UNITED STATES PATENT AND TRADEMARK OFFICE

10/774,899

Office Action Summary	Application No. 10/774,899	Applicant(s) SMITH ET AL.	
	Examiner Allen C. Ho	Art Unit 2882

DETAILED ACTION

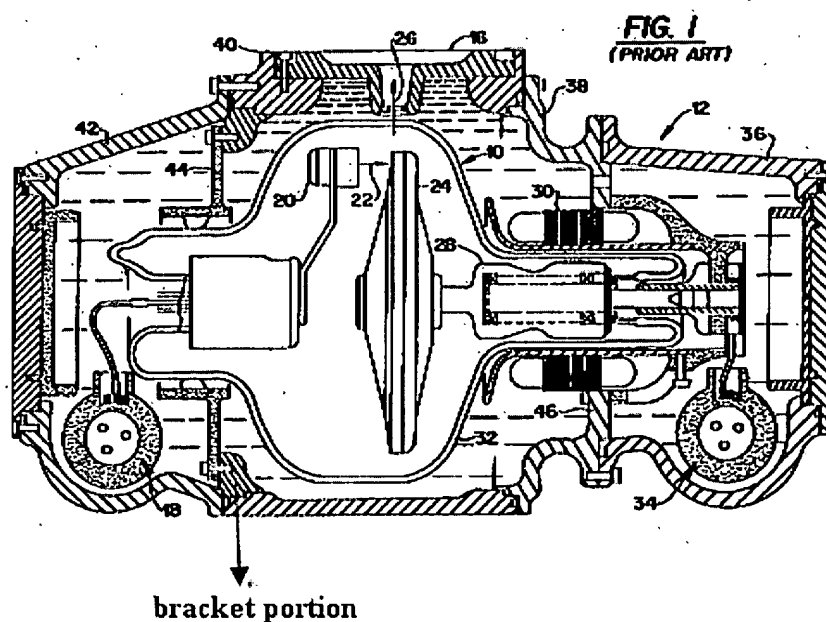
With regard to claim 1, Kantor *et al.* disclosed an x-ray tube comprising: an evacuated enclosure (32) containing an electron source (36) and an anode (34) positioned to receive electrons produced by the electron source; an outer housing (16) containing the evacuated enclosure; and a mounting portion comprising: a first mounting portion (20) that mechanically attaches to an outer surface of the outer housing, and a second mounting portion (54) that mechanically attaches to a portion of the evacuated enclosure, the second mounting portion also

being mechanically attached to the first mounting portion through an aperture (through which the first mounting portion is inserted into the outer housing) defined in the outer housing (see Figure).

With regard to claim 7, Kantor *et al.* disclosed an x-ray tube as defined in claim 1, wherein the mounting assembly is further configured to mechanically attach the x-ray tube to a portion of an x-ray generating device (10).
